## **RANGELINE-HAMILTON COMMERCIAL PARK**

### **SUBDIVISION**

APPLICATION NUMBER Holdover DATE May 6, 2004  
APPLICANT Rangeline-Hamilton Commercial Park Subdivision  
REQUEST Subdivision

# RANGELINE-HAMILTON COMMERCIAL PARK SUBDIVISION

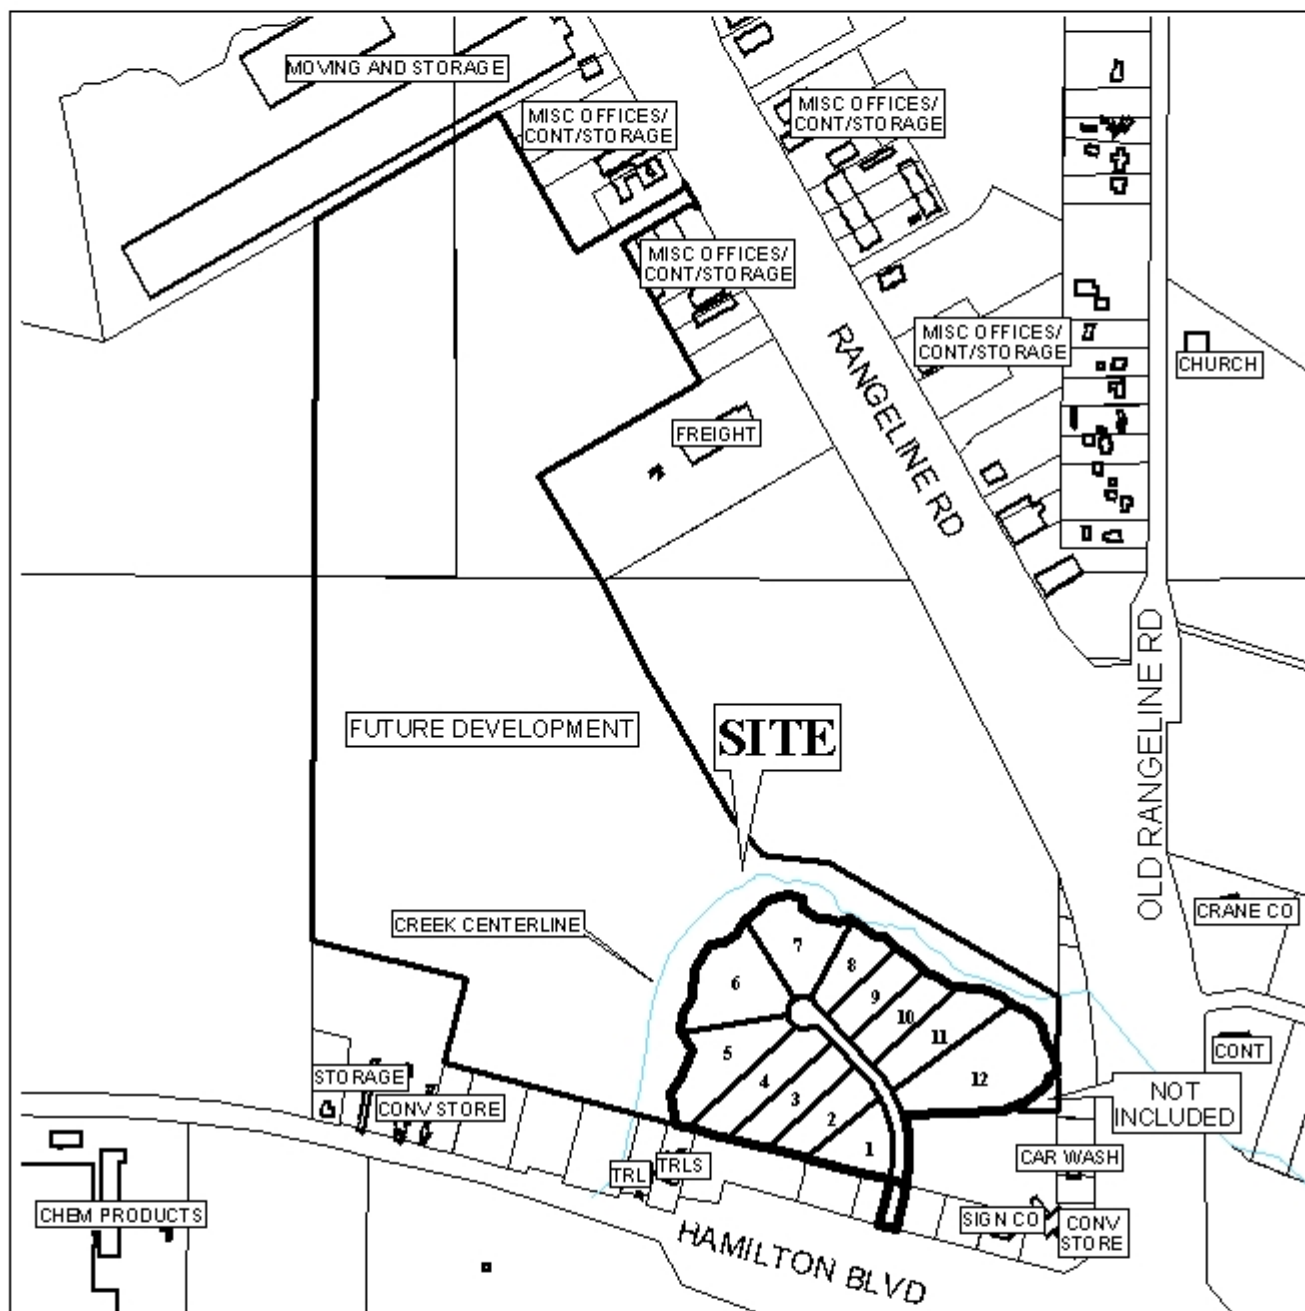
*The application was heldover to allow the applicant to include the remainder of the property and the revised plat illustrates that the future development will have access to Rangeline Road. However, as illustrated on the Vicinity Map, a small portion of property adjacent to Lot 12 is not included and would be landlocked. As this piece of property would be landlocked, this small portion of property should be incorporated into Lot 12.*

As proposed, Lots 3-8, 11 and 12 would exceed the maximum width to depth ratio; therefore a waiver of Section V.D.3 would be required. Furthermore, the 25-foot minimum building setback line is not shown but would be required on the final plat.

As illustrated on the Vicinity Map, the site includes an unnamed creek, thus this area could be considered environmentally sensitive; therefore, the developer must obtain any necessary federal, state, and local environmental approvals.

With a waiver of Section V.D.3, the plat will meet the minimum requirements of the Subdivision Regulations and is recommended for Tentative Approval subject to the following conditions: 1) the landlocked piece of property be incorporated into Lot 12; 2) the placement of the 25-foot minimum building setback line on the final plat; 3) the obtaining of any necessary federal, state, and local approvals; and 4) the placement of a note on the final plat stating that if the property is developed commercially and adjoins residential property, a buffer, in compliance with Section V.A.7. of the Subdivision Regulations will be provided
